Memorandum

Subject: Responses to Comments for the Bear Street Residential Project in Costa Mesa, California

Costa Mesa Sanitary District Access Exhibit

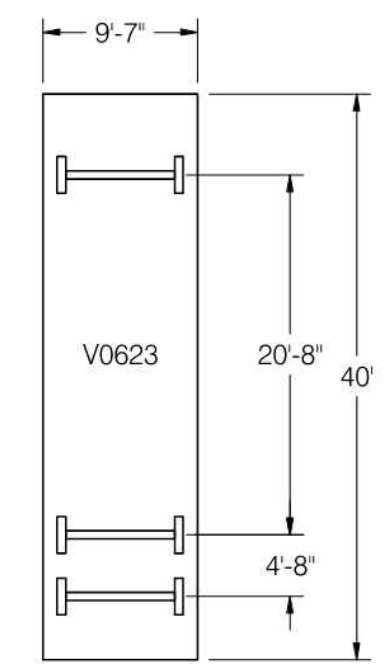
On-Site Delivery Access -The residential design lacks clarity on how delivery and service vehicles (e.g., moving trucks, package vans, utility trucks) will circulate and access units, particularly in a high-density townhome setting. Recommend ensuring:

- Adequate turning radii for delivery trucks.
- Temporary curb loading zones that do not block travel lanes or pedestrian access.
- Shared delivery package lockers or designated delivery zones to reduce repeated vehicle idling and circulation.

A truck turn analysis and exhibit (see Attachment D) was prepared specifically for Costa Mesa Sanitary District sewer utility truck access to and within the site. Furthermore, the proposed project has been designed to allow for adequate fire truck turning radii. This would also apply to delivery trucks visiting the project site. Private drives A through F would provide adequate width for truck access. Furthermore, there are four utility access road turnouts within the site. Mailboxes are located along private drive A and private drive F.
